Address (list all addresses on the project site): 6701 McKee Road

Title: McKee Rd. Mixed-Use

UDC meeting date requested [redacted] January 22, 2025

SHEET TITLE
LANDSCAPE PLAN
AFTER

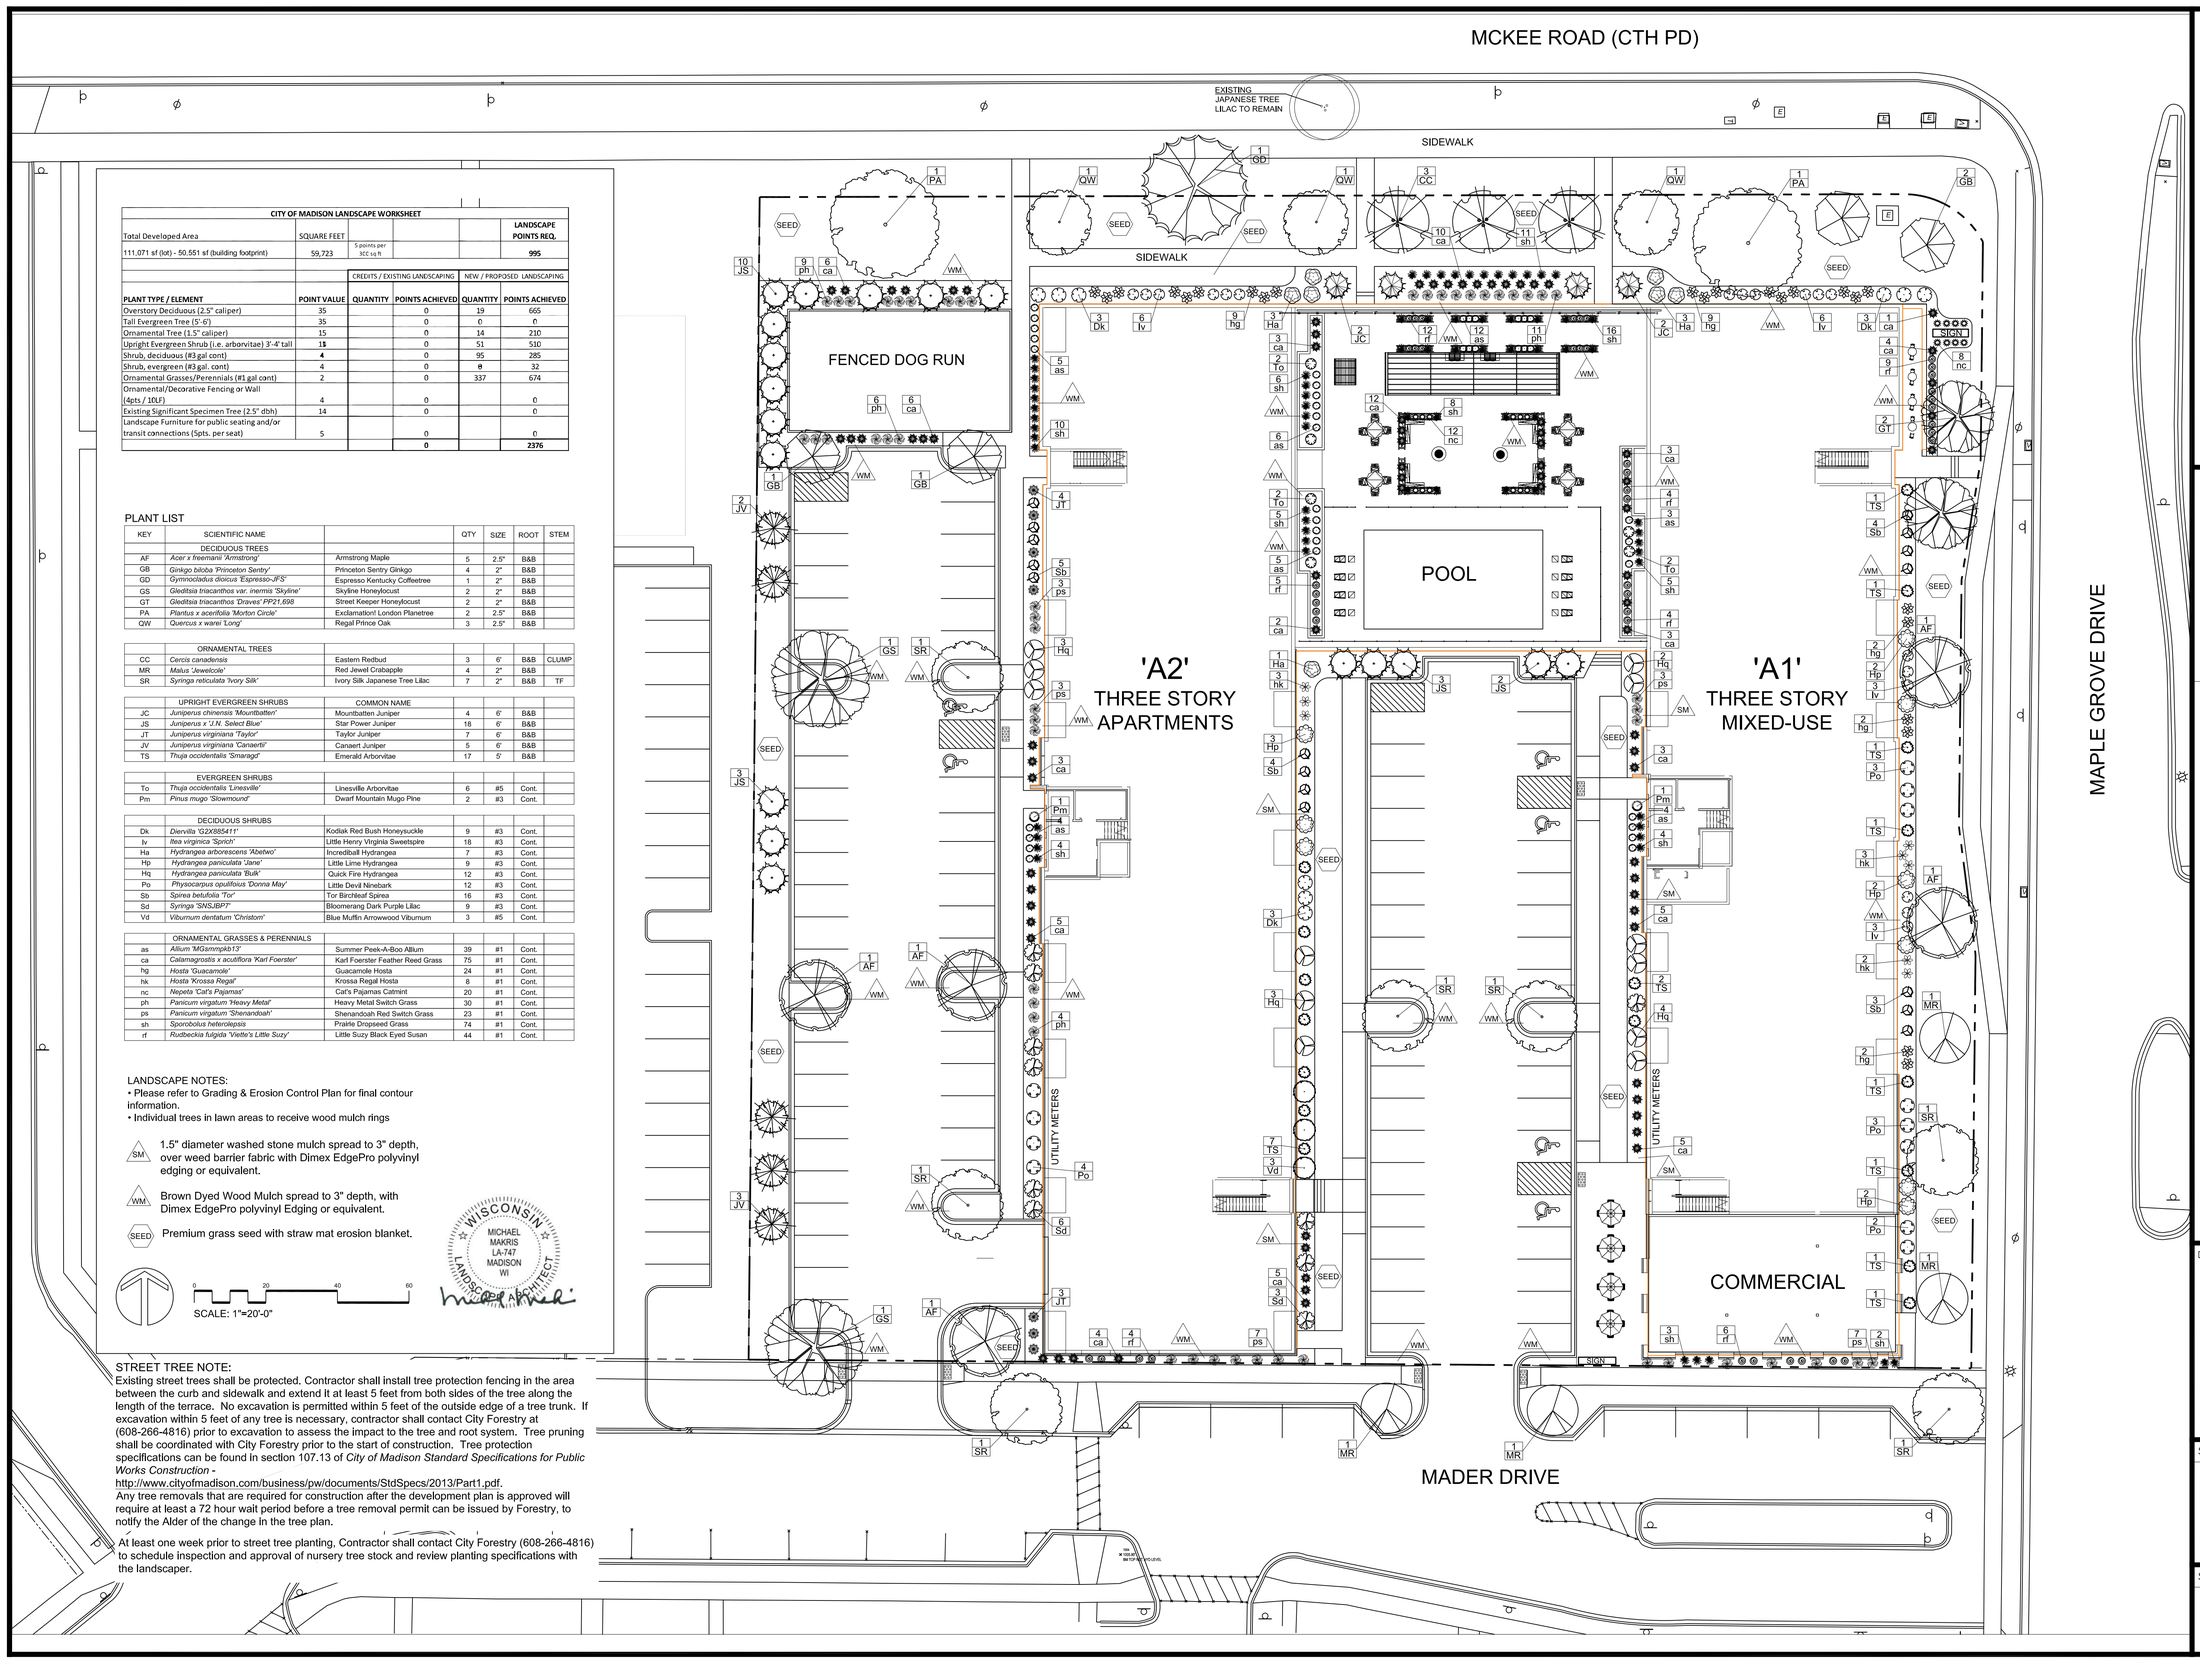
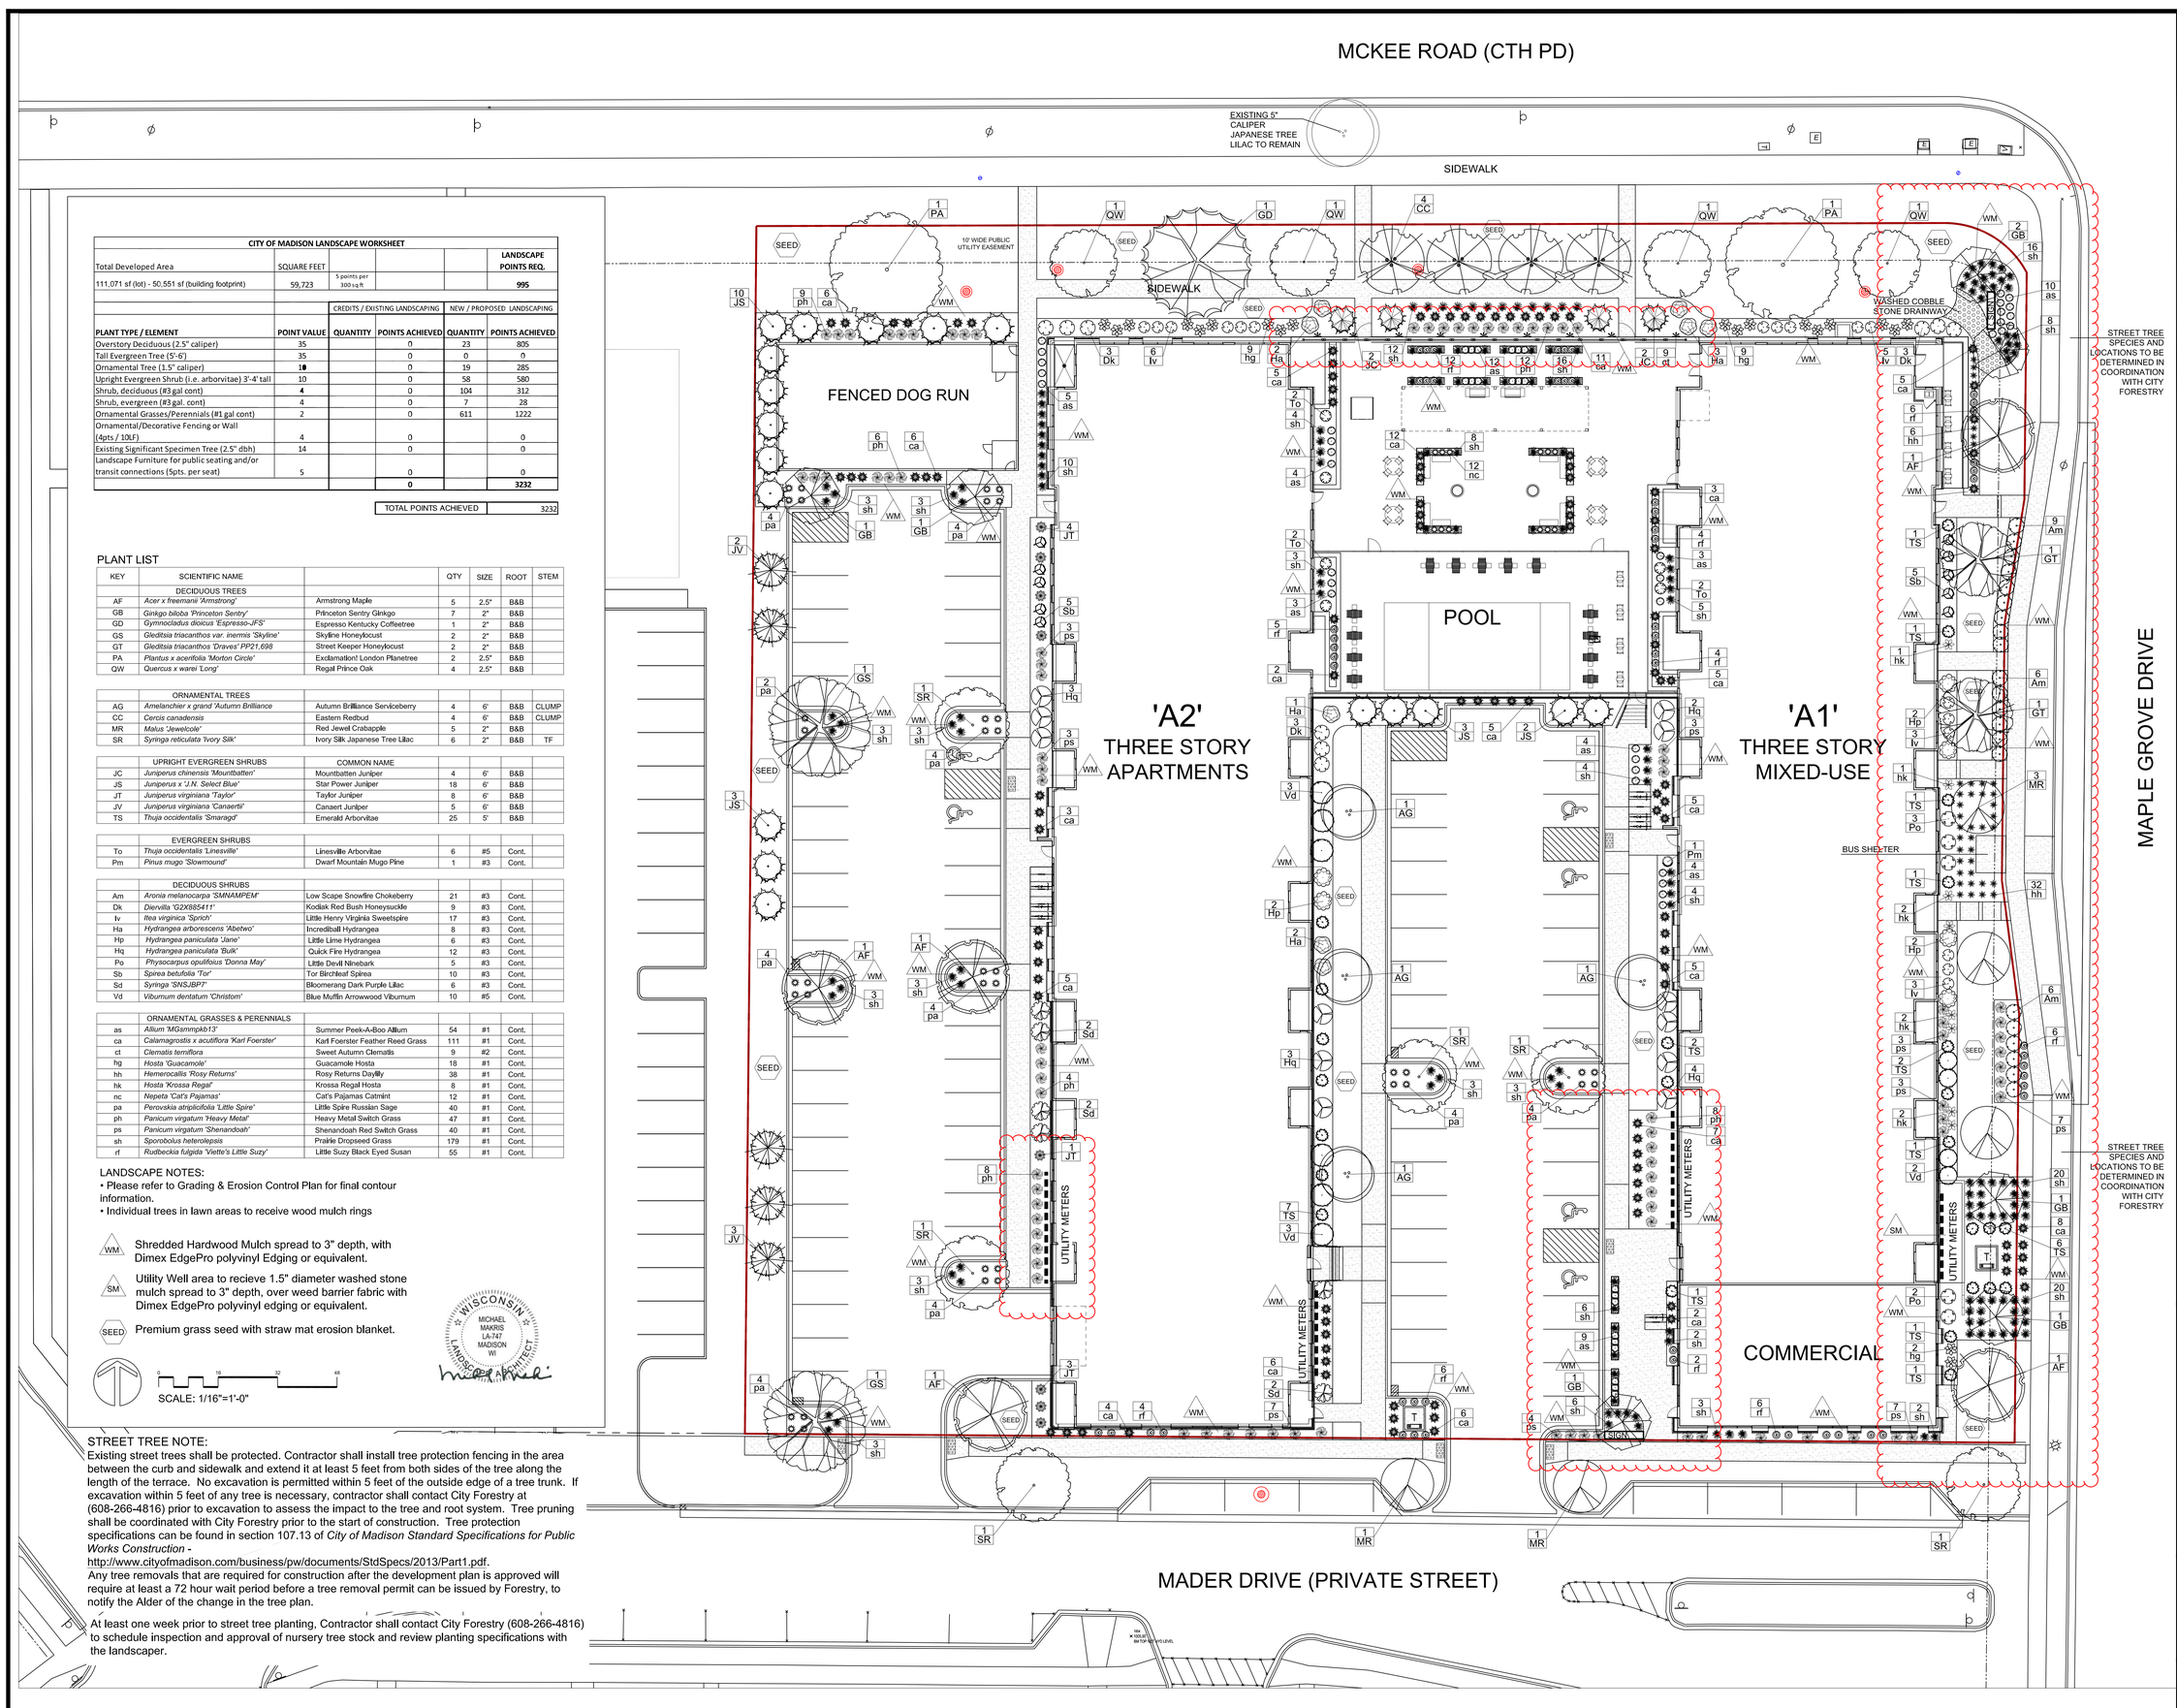
- Revise the landscaping plan to fill in the lawn area at the NE corner of McKee Rd and Maple Grove Road with additional plantings to look more intentional and substantial; reflect climbing vegetation be planted in the raised boxes to soften the hardscape area and return areas of stone mulch to shredded bark mulch to support plant life and hold moisture.

- *The monument sign was rotated 90 degrees and moved out of the easement.*
  - *Trees and shrubs were added to make the area more intentional and substantial.*

- *Sweet autumn clematis was added to the fence*
  - *Mulched areas are marked with WM – symbolizing wood mulch.*
  - *The previous landscaping plan is included to compare with the proposed landscaping plan.*

SECTION DETAIL:
TILT-UP CONCRETE WALL TO SIDING WALL TRANSITION

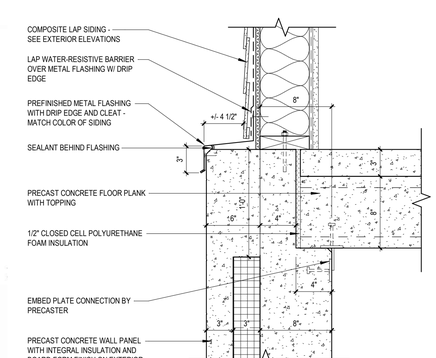
- Provide details of the material transitions where the board formed concrete sandwich panel transitions to the fiber cement material.
  - *The sandwich panel (tilt up precast panel) will be capped with metal 'Z' flashing that transitions to the fiber cement material. (see detail on U220)*
  - Material transition details included on U220
- *Provide the coping/cap finish detail for the board form concrete sandwich panel.*
  - *The board form concrete will be poured as part of a tilt up precast panel.*
  - *The panel will be a uniform color, with a slight texture – see below*
